DEVIATION REVIEW AND DECISION FORM

Subdivision or Project Name: The Ranch Sketch Plan

Section of ECM from Which Deviation is Sought: 2.2.5.B.1

Specific Criteria from Which a Deviation is Sought: Intersection spacing along a Principal Arterial

Deviation Exhibit

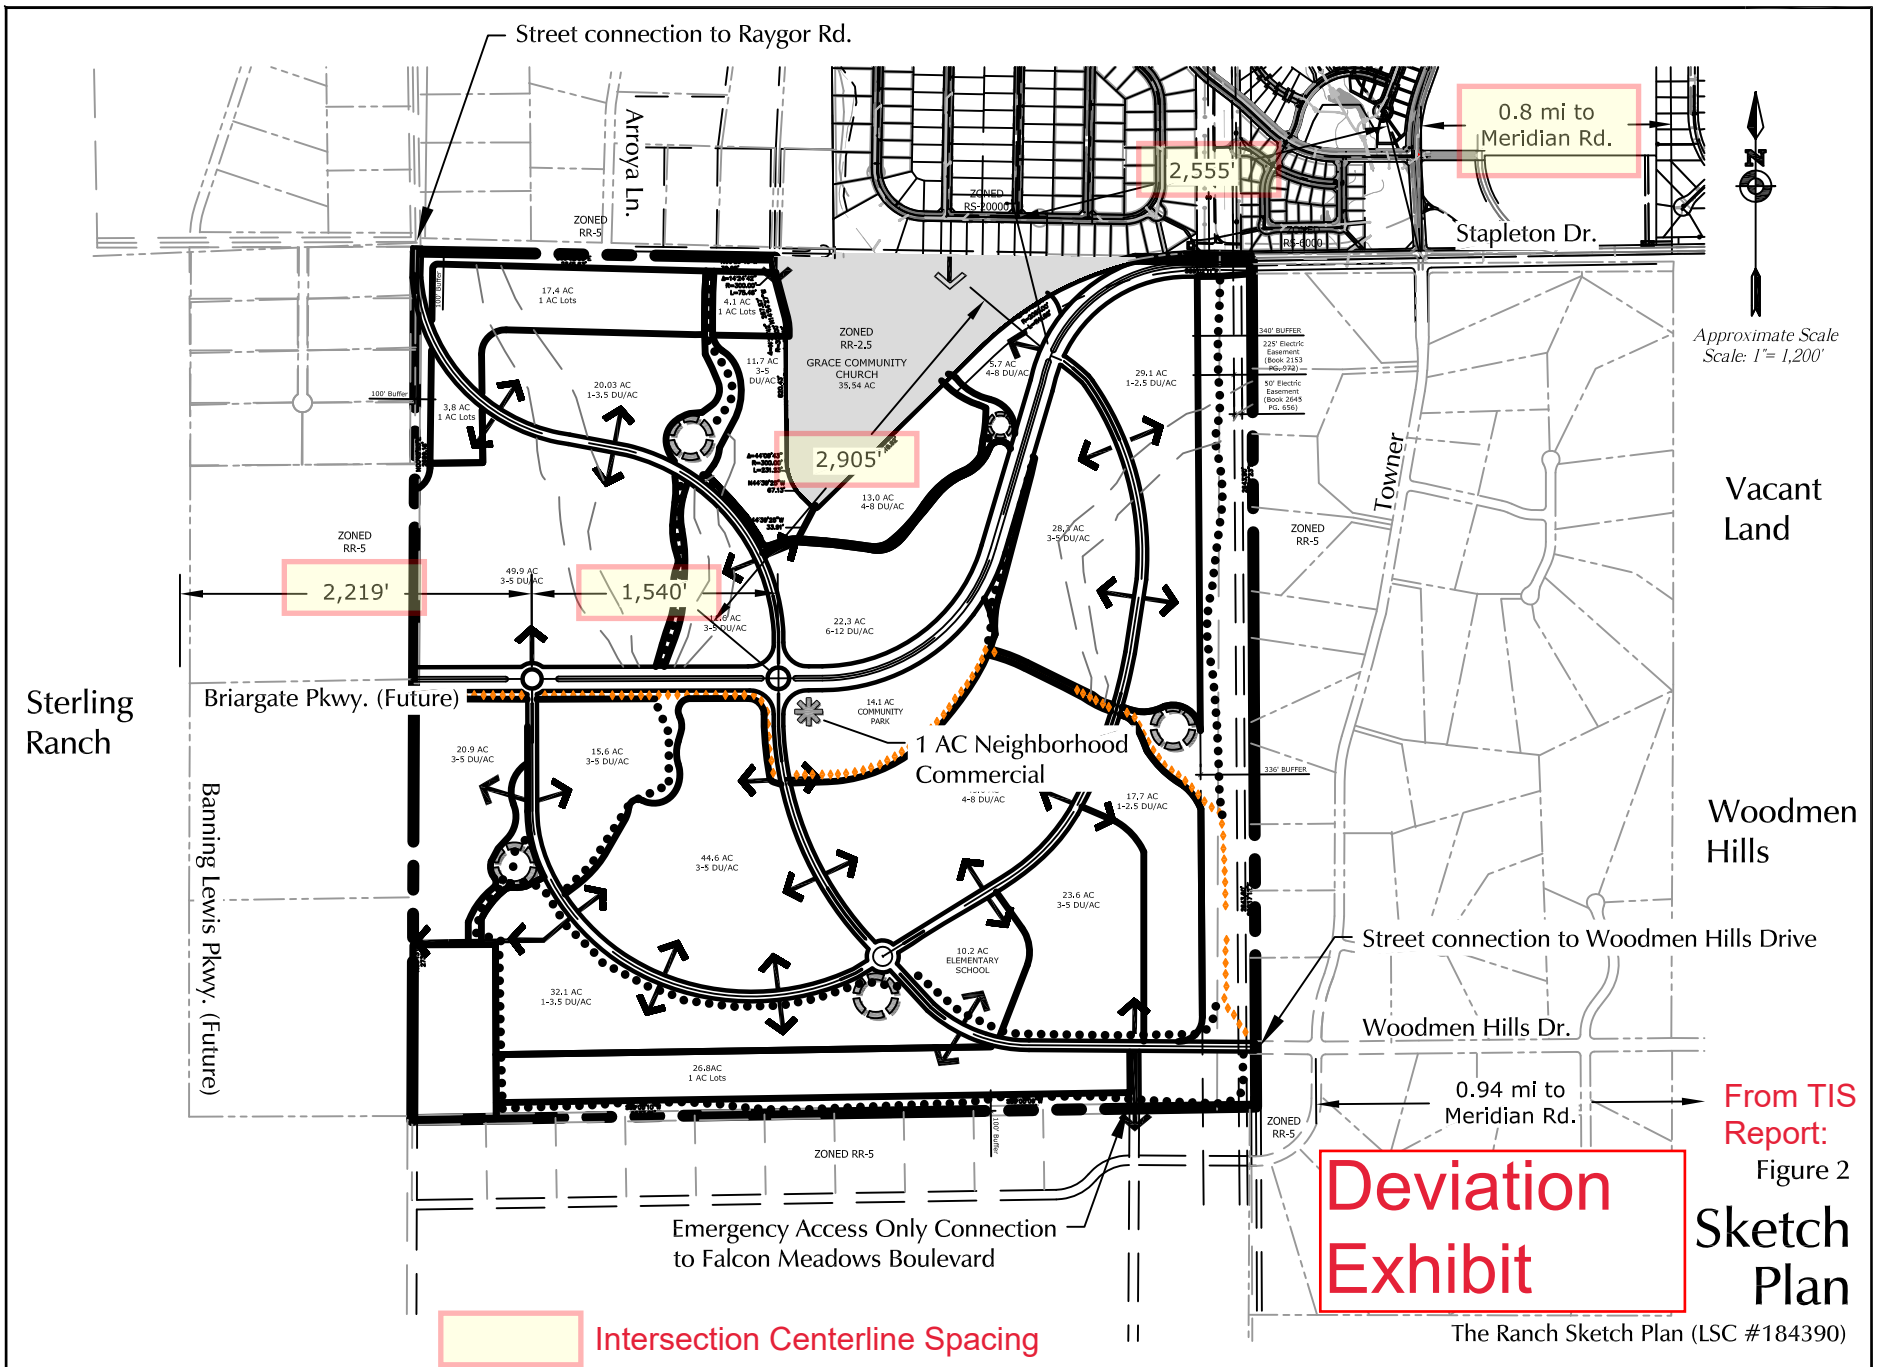
Proposed Nature and Extent of Deviation: Request for full-movement, future public street intersections along the planned future Stapleton Drive/Briargate Parkway (a planned four-lane, Urban Principal Arterial) with the intersection spacing dimensions shown on the proposed Sketch Plan. The centerline spacings from east to west from the Stapleton/Towner intersection to the planned future intersection of Banning Lewis Parkway/Briargate shown on the Sketch Plan are 2,550 feet, 2,900 feet, 1,550 feet and 2,200 feet. Please refer to attached exhibit. The first intersection west of Towner is shown as a conventional four-leg, full-movement intersection and the proposed

The intersection spacing of the first intersection west of Towner would only be 90 feet short of the half-mile standard. This would not be a significant departure from the standard - even from the perspective of signal spacing. The spacing between the two proposed roundabouts and the proposed west roundabout and the future Banning Lewis Ranch/Briargate intersection would not be problematic. Signal progression would not be relevant through these planned roundabout intersections, and the spacing would be more than sufficient for tapers, transitions, and any auxiliary turn lanes on the westbound approach to Banning Lewis Parkway. The proposed roundabout spacing would exceed the spacing of the Research Parkway roundabouts in Wolf Ranch (City of Colorado Springs). The provision for two roundabouts instead of one would allow roundabouts to be utilized as traffic control devices - with one roundabout intersection, the roundabout capacity would likely be exceeded.

The deviation would not adversely affect operations or safety as the signal spacing on the east side of the project is within 90 feet of meeting the one-half mile standard. The roundabout spacing is less than one-half mile, however, signal progression would not be relevant through these planned roundabout intersections and the spacing would be more than sufficient for tapers, transitions, and any auxiliary turn lanes on the westbound approach to Banning Lewis Parkway; The provision for two roundabouts instead of one would allow roundabouts to be utilized as traffic control devices - with one roundabout intersection, the roundabout capacity would likely be exceeded. In general, roundabout intersections have safety benefits when compared to signalized intersections; The shorter-than half mile spacing may potentially be better than half-mile spacing as the segment lengths between them may reduce speeds and the amount of acceleration and deceleration behavior between the roundabouts when compared to longer distance between them.

This request has been determined to have met the criteria for approval. A deviation from Section
_2.2.5.B.1 of ECM is hereby granted based on the justification provided. Comments:

This approval is conditional with the use of the proposed
roundabouts. If roundabouts are removed, the approval is
revoked.
